4.16 INSERVICE INSPECTION OF STEAM GENERATOR TUBING

STEAM GENERATOR TUBE/ANTIVIBRATION BAR WEAR
AND TUBE DENTING EVALUATION
SAN ONOFRE NUCLEAR GENERATING STATION UNIT 1

DESCRIPTION OF PROPOSED CHANGE AND SAFETY ANALYSIS OF
PROPOSED CHANGE NO. 172 TO THE TECHNICAL SPECIFICATIONS
PROVISIONAL OPERATING LICENSE DPR-13

FIGURE 1

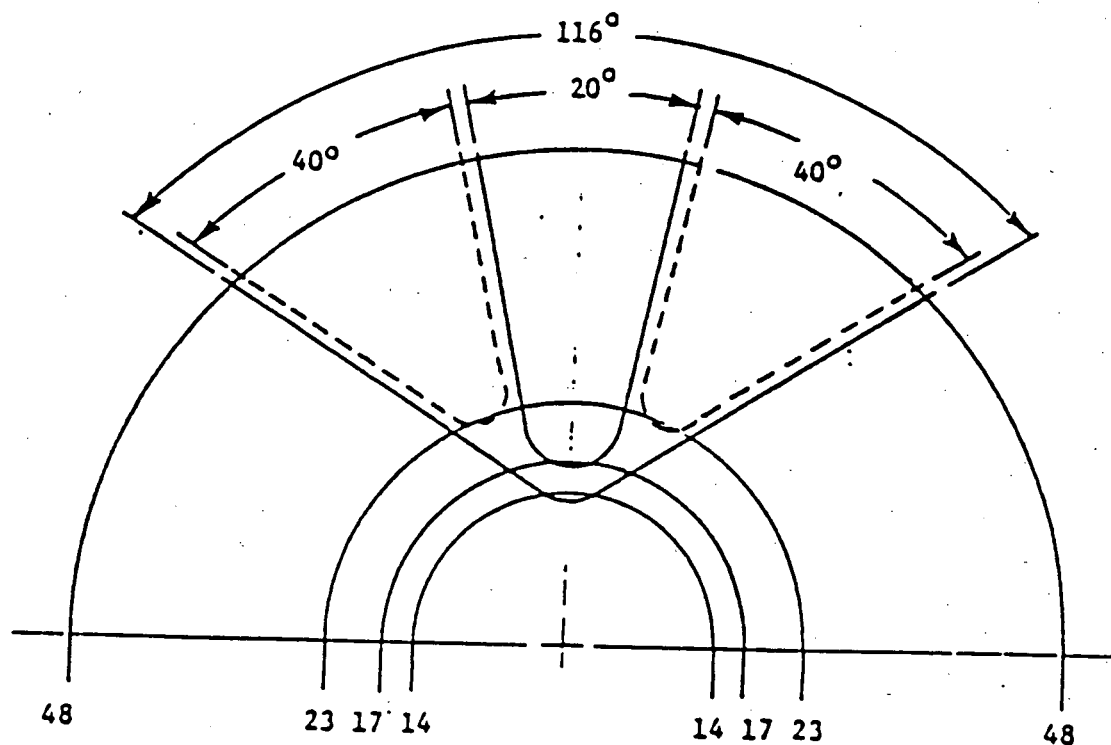
The SONGS-1 steam generators were manufactured with round, carbon steel AVBs. Fretting wear of tubes at many of these AVB intersections led in 1976 to the installation of square, chrome plated, Inconel AVBs between and adjacent to the originally installed AVBs as depicted in Figure 1. The additional AVBs are considered to have substantially impeded, if not eliminated, the fretting and wear processes. This conclusion is based on operating experience and eddy current examination results since their installation.

AVB inspection results (Table 5) show that the installation of the square AVBs has apparently arrested the fretting/wear process by tightening the upper bundle and restraining tubes against flow induced vibration. Therefore, the AVB indications of primary concern are those associated with the original round bars. The shapes of flaws at round AVB intersections, as evidenced by U-bend specimens removed from SONGS-1, are dish-like with axial and circumferential extents on the order of the AVB diameter (1/4") and with varying depths. Specimens of round AVB bars removed, show that the bars themselves are worn in dish-like patterns to varying extents at areas of contact with tubes. Thus, there are probably as many different combinations of flaws and worn AVBs at tube/AVB intersections, as there are intersections. Compounding these possibilities is the varying degree to which the round AVBs may or may not be in contact with tubes. Depending on factors such as the extent of AVB and tube wear, the size of the gap between tubes created by the square AVBs, tube pitch alignment in the upper bundle, etc., the degree of contact between round AVBs and tubes can range from intimate contact to a sizable gap between tube and AVB. Finally, due to tube bundle expansion and contraction during steam generator heat-up and cool-down, relative motion may occur between AVBs and tubes at some intersections resulting in axial offset of tube/AVB intersections in cold conditions versus operating conditions.

NEW ARRANGEMENT : Add V Bars Between Existing V Bars and Attach to Existing Retainer Ring

NOTE: The modification affects tubes in columns 18 through 83 inclusive.

FIGURE 2

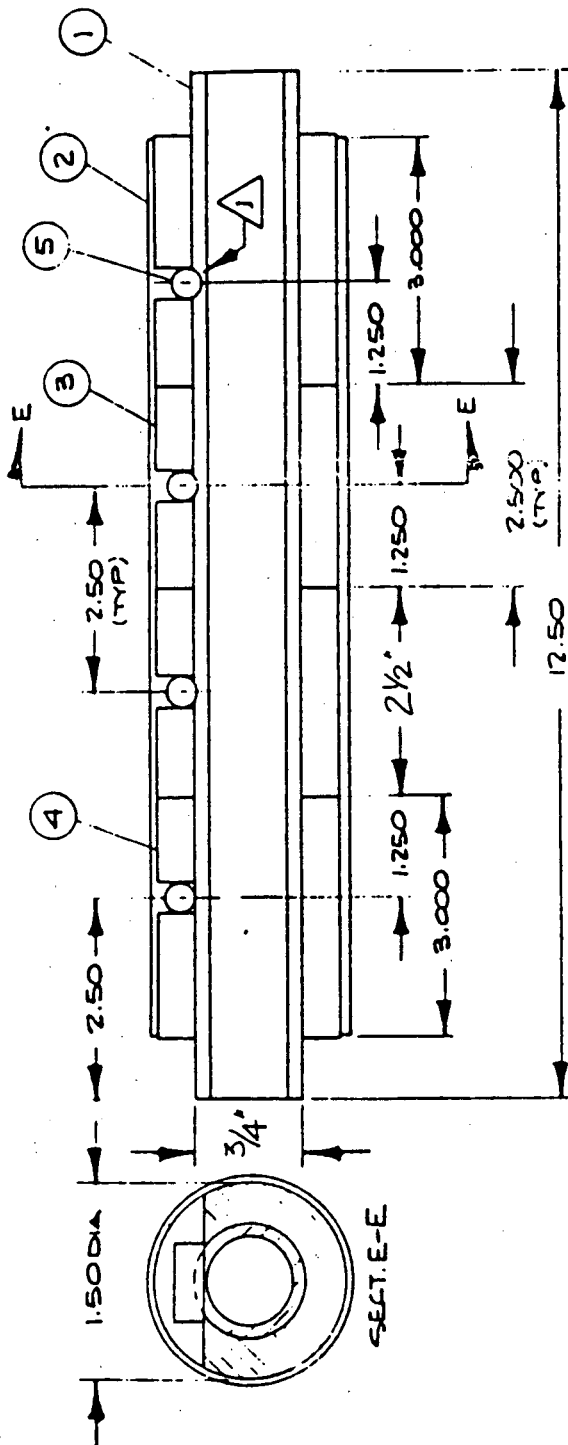
Beginning in 1984, both multifrequency eddy current testing techniques and an AVB standard (Figure 2) were utilized at SONGS-1 to discretely quantify AVB wear indications. Mixing techniques, amplitude analysis and the use of the absolute mode were utilized to minimize the inherent ambiguity in the examination of AVB wear indications. In the test itself, both the ASME standard with carbon steel support ring and the AVB standard are used. Usually, only differential phase vs. depth analysis is done with the ASME standard, while absolute and/or differential amplitude vs. depth analysis, as well as phase analysis, is done with the AVB standard.

Utilizing these new techniques, AVB wear indications are now quantifiable in the same range (greater than 20 percent through wall) as other defect indications. At SONGS-1, all previous AVB wear indications have been inspected in all three steam generators and have been given a discretely quantifiable defect depth (if greater than 20 percent through wall).
